# ***Interactive comment on “Sub catchment Assessment of snowpack and snowmelt change by analyzing elevation bands and parameter sensitivity in the high Himalayas” by Vishal Singh et al.***

**Vishal Singh et al.**

Received and published: 4 May 2017

Fig. 1: (a) Study area map of Satluj river catchment (up to Kasol gauge).

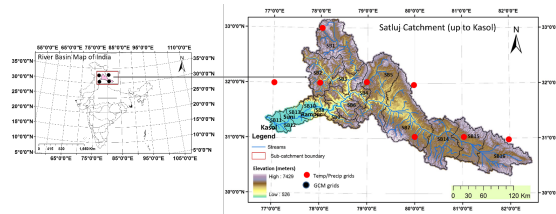
1- “... however, the methods section does not contain any information on how many

meteorological stations were included in the analysis nor where these stations are located.”

Line 134: A little bit more information on the HRU delineation is needed. How many HRUs were derived for each sub-catchment? What curve numbers were assumed for the different soil types (which are not clearly defined in Figure 1!)? How were the 10 elevation bands derived (e.g. natural break, equal interval, equal area)? Why not use local information on the lapse rate to define the elevation bands?

Figure 1: What do the black circles with the cross mean? Please ensure that each map shows a complete legend! The legend of the soil map is very uninformative. Could the different soils be grouped into know soil types or soil families? The 16 sub-catchments and their boundaries are hard to see. Please use a different line and text color for the catchment boundaries. Please add locations of glaciers within the basin. Also the locations of the three gauges mentioned in the methods cannot be found in any of the figures.

Additional details and clarity have been added to input data descriptions, which led to an enhanced narrative connected with updated Figures (See Figure 1) illustrating the location of the stations.

In Table 1 we have provided the model simulation details like HRUs and other water balance components. Figure 1 has been modified and soil and LULC classes are explained now in a better way.

[Total 8 grids which are falling inside/near to the catchment have been selected (Fig. 1a). These datasets have been generated using more than 1800 observed precipitation and temperature gauges distributed across India.

Figure 1 has been restructured.

**Fig. 2 (a):** Scatter plots of daily calibration (1991-2000) and validation (2001-2008) at three outlets: (a) Rampur calibration, (b) Rampur validation, (c) Suni calibration, (d) Suni validation, (e) Kasol calibration, (f) Kasol validation.

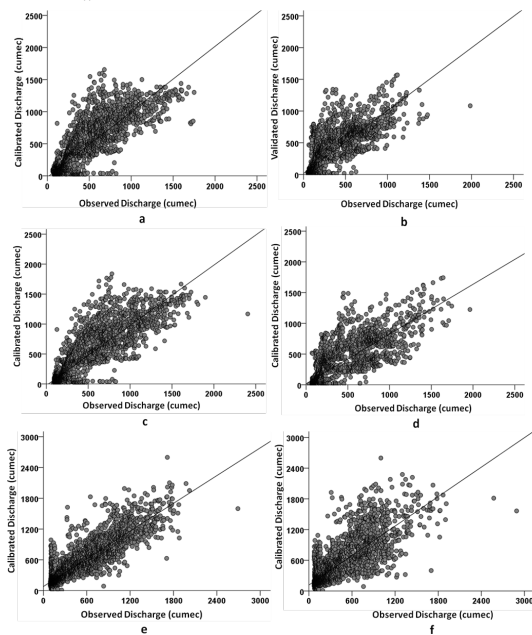
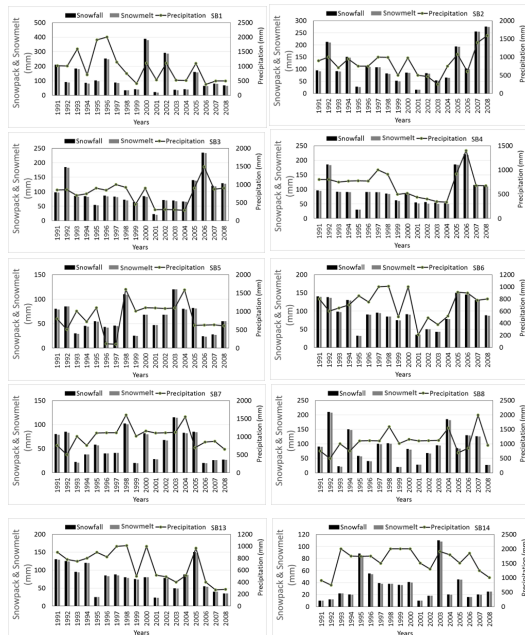
3- “ . . . attempt to improve uncertainty propagation of these huge uncertainties in the input data.”

Figure 2: Please correct the spelling of “snowmelt” in each graph. Please define what you mean by snowpack and snowmelt. Is snowpack the depth of the snowpack and snowmelt the snow water equivalent? Corrected. Snowpack (depth). Figure 4: The figure caption for this figure does not make sense. Graph (b) does not seem to show the cumulative variability in snowpack amount as stated in the caption.

We enhance the representation of the model performance in the calibration and validation stages. Table 4 was improved and Figure 2 developed to show these key aspects of modeling hydrologic processes.

Fig. 6. Changes and inter annual comparisons in average annual (a) precipitation, (b) snowpack/snowfall, (c) snowmelt, (d) water yield (due to snow) and (e) total water yield (snowmelt and rainfall runoff) over the study area in different temporal climate domains (1991-2030).

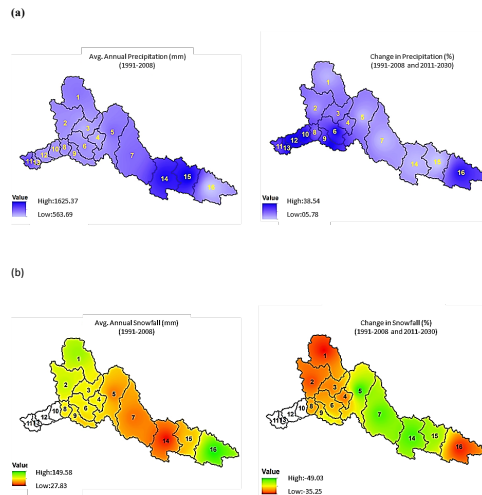
Figure 6: This figure is somewhat awkward. The labels for each plot are too big and cover in some instances the map. I would suggest putting each map into a grid/frame that is then clearly labeled with both a-j and the thematic title of the map.

Grid frame will reduce the spatial variations because at smaller scale the resolution of the figures will be distorted. The grid is not needed as their extent coordinate values we have already explained in the text (study area section). The captions are needed to explain each figure.

Fig. 7. Percentage of change in snowpack amount (average annual) over different sub-catchments of Satluj river.

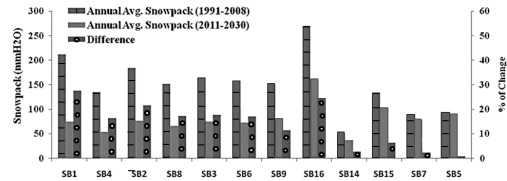
Line 397: How would a change in elevation bands influence the results shown in Figure 7? Explained.

Fig. 7: Why are the bar graphs not sorted in increasing order from SB1-SB16 along the x-axis? SB5 is the last bar with the least change in snowpack but it is not clear what elevation band this sub-catchment belongs to. We considered that the current order reflects the geographical context rather than the numerical values assigned to each sub-catchment.

[Figure 7 illustrates the magnitude of change (shown as “% of change”) in snowpack amount as a function of the fraction of elevation bands. At each sub-catchment, the snowpack differences have been computed and analyzed by comparing historical and near term scenarios. The results showed significant decrease in snowpack amount across all the snowpack-dominated sub-catchments. A 5% (minimum) to 42% (maximum) decrease in snowpack has been accounted across all the sub-catchments. This contributes to evidence increasing temperatures in snow cover and glacier melting over Himalayan catchments. The sub-catchments SB1, SB2, SB3, SB8 and SB16 correspond with the utmost decrease in snowpack amount (20% to 42%); whereas, the sub-catchments SB5, SB7, SB14 and SB15 SB16 showed a small to moderate decrease in snowpack amount (4% to 20%). Also, SBs, situated at high elevation areas showed larger changes or decreases in snowpack with respect to the moderate-elevation SBs. This illustrates a conspicuous warming trend at high elevation portions with respect to those at moderate and low elevation ranges.]
